Porirua proposed District Plan and Variation 1

Further comments by Martin Gledhill

Fig 1. Heights above which EMF exposures may not comply with public limits in NZS 2772.1 as a function of distance from the RNZ Titahi Bay mast.

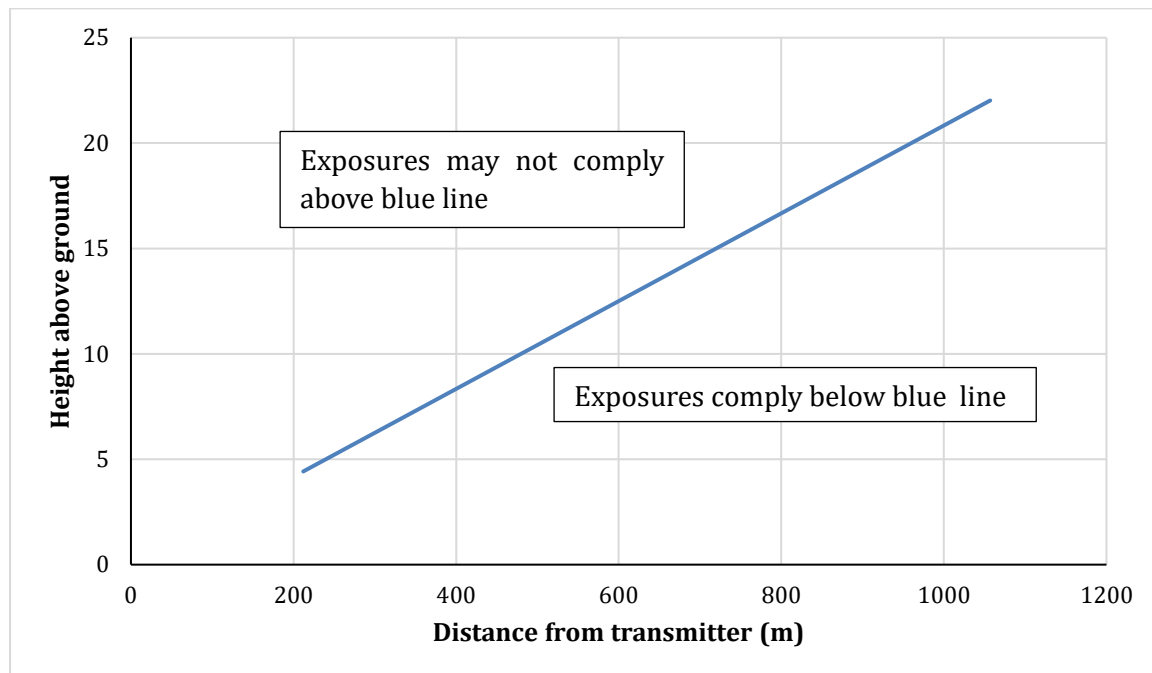
3. I would like to emphasise that this is a conservative evaluation. The calculations are based on worst-case assumptions, and the limits in NZS 2772.1 are also based on worst-case assumptions.

4. In the JWS we noted that an EMF assessment would only be required if building heights exceed the limiting height shown by the blue line in figure 1. Similarly, an EMF safety plan would only be needed if the height of construction equipment exceeded that limiting height.

Fig 2. Heights above which EMF exposures may not comply with public limits in NZS 2772.1 as a function of distance from the RNZ Titahi Bay mast (blue line), and heights at which it is proposed that EMF assessment is required (red line).

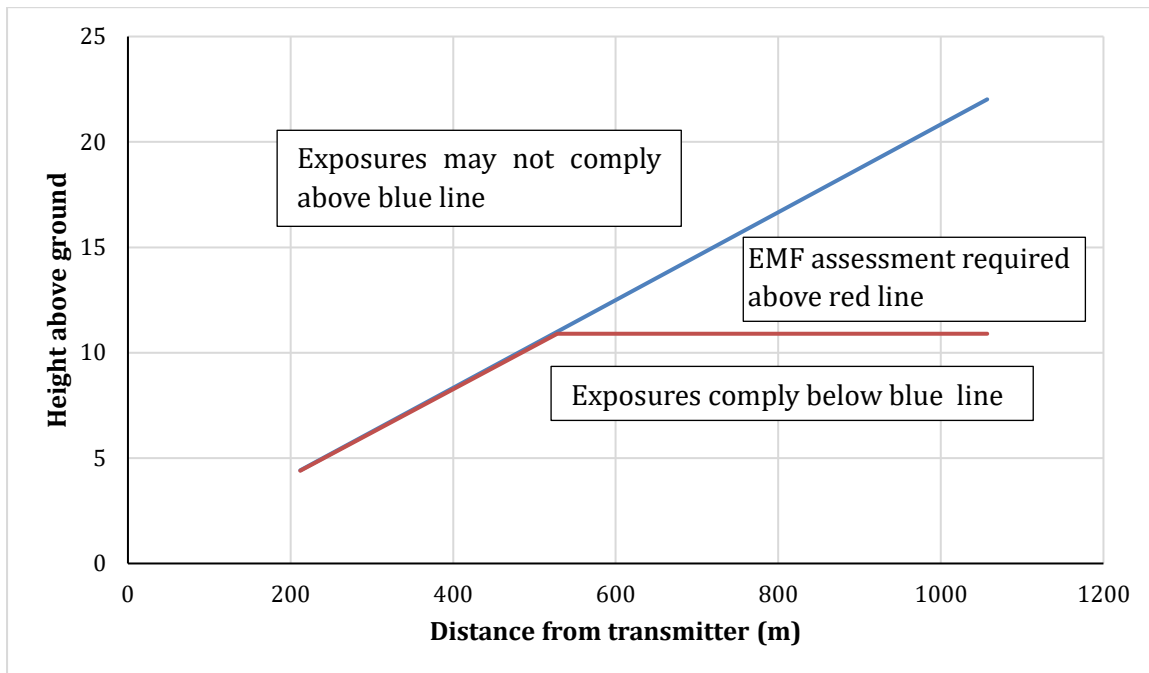
5. Mr Smeaton's revised rules have only taken this into account at distances less than 528 m from the mast (Radio Transmission Height Control Area A (RTHCA-A)). At distances from 528 m to 1057 m (RTHCA-B) he proposes that an EMF assessment is required for proposed buildings taller than 11 m.

6. In addition, an EMF assessment is also required for temporary structures taller than 11 m in RTHCA-B.
7. I have plotted these revised rules in figure 2. Any building or temporary structure whose height is above the red line would require an EMF assessment.

Fig 2. Heights above which EMF exposures may not comply with public limits in NZS 2772.1 as a function of distance from the RNZ Titahi Bay mast (blue line), and heights at which it is proposed that EMF assessment is required (red line).

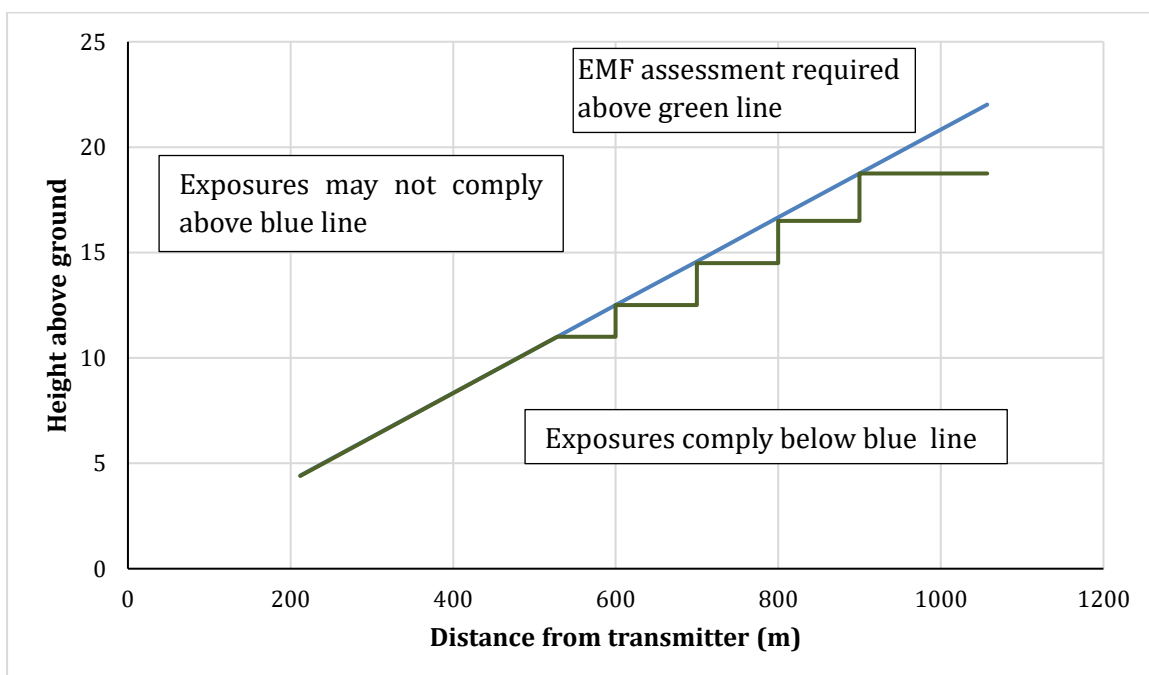
8. In my opinion, there is no value in requiring an EMF assessment at heights below the blue line, because the conservative EMF analysis shows that exposures would comply with public limits. It would be preferable to simply have one RTHCA that extends out to 1057 m, and have the scope of AAP16 also extend out to 1057 m.
9. I note that Karen Williams for Kainga Ora has proposed an alternative rule that provides a closer approximation to the blue line but which may be easier for users of the Plan to use. I have plotted this as the green line in figure 3.

10. In my opinion the rule proposed by Kainga Ora is preferable to that proposed by Mr Smeaton, and would result in far fewer unnecessary EMF assessments.
